PRODUCT/PROCESS CHANGE NOTICE (PCN)

PCN #: **TB1503-01 (R1)** DATE: **October 23, 2015**
 Product Affected: **TSSOP-20, TSSOP-24, TSSOP-28,
 TSSOP-48, TSSOP-56, TVSOP-48
 SOIC-28, SSOP-20, SSOP-28,**
 (Refer to Attachment II for affected part# shipped in Reel)
 Date Effective: **February 1, 2016 Earliest Date - Refer to
 specific date by package type**

ATTACHMENT I - PCN #: TB1503-01 (R1)

Figure 1: Additional Label pasted on ESD/Moisture barrier bag and Pizza box

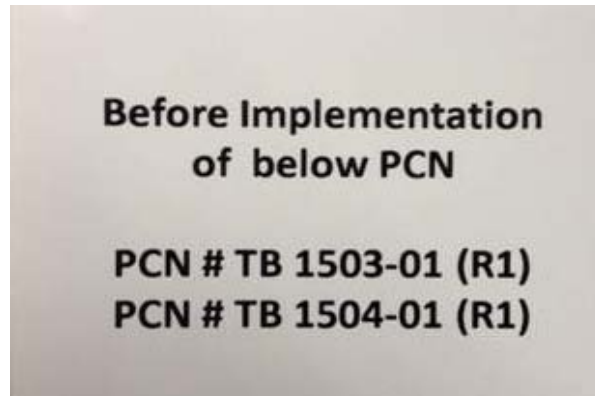
Customers may expect to receive shipments of products in new packing no sooner than 90 days from the date of this PCN notification. Shipments to customers may contain products shipped with either the existing packing or new packing during the transition period. Shipments made in the existing packing after the PCN becomes effective will have an additional label pasted on the ESD/moisture barrier bag and pizza box.

Illustration of Carrier Tape Pocket Design Change

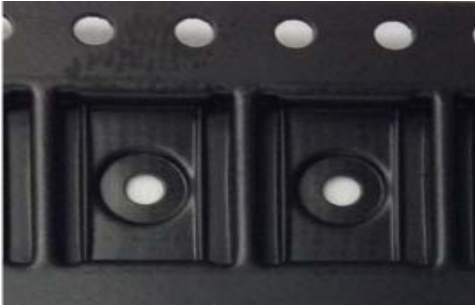
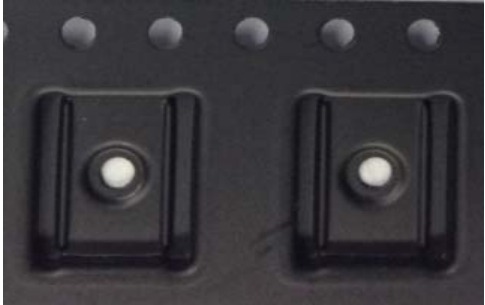
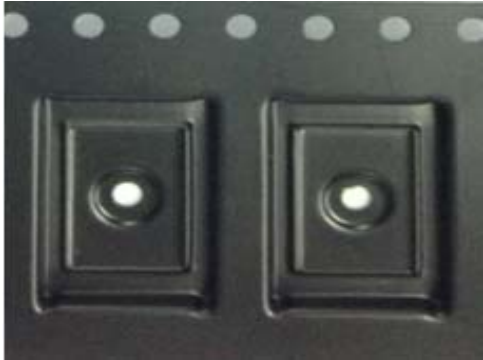
Package	From	To
TSSOP-20	Carrier Tape Part# P8-464-000 	Carrier Tape Part# P8-291-P20 
TSSOP-24	Carrier Tape Part# P8-329-P24 	Carrier Tape Part# P8-169-P24 
TSSOP-48	Carrier Tape Part# P8-260-P48 	Carrier Tape Part# P8-324-P48

Illustration of Carrier Tape Pocket Design Change

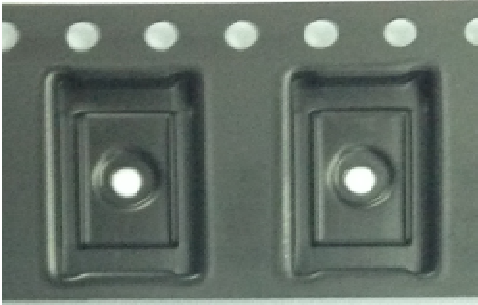
Package	From	To
SOIC-28	Carrier Tape Part# P8-187-S28 	Carrier Tape Part# P8-370-P28 
TSSOP-28 and TVSOP-48	Carrier Tape Part# P8-145-PF8 	Carrier Tape Part# P8-330-P48 
TSSOP-56	Carrier Tape Part# P8-261-P56 	Carrier Tape Part# P8-314-P56

Illustration of Carrier Tape Pocket Design Change

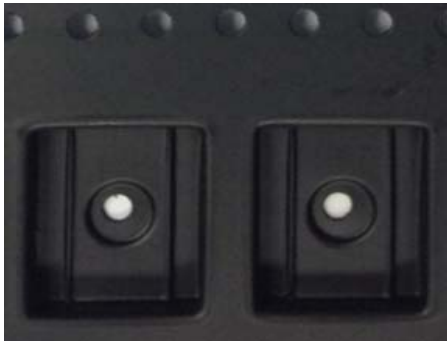
Package	From	To
SSOP-20	Carrier Tape Part# P8-259-P20 	Carrier Tape Part# P8-320-P20 
SSOP-28	Carrier Tape Part# P8-384-P28 	Carrier Tape Part# P8-321-P28
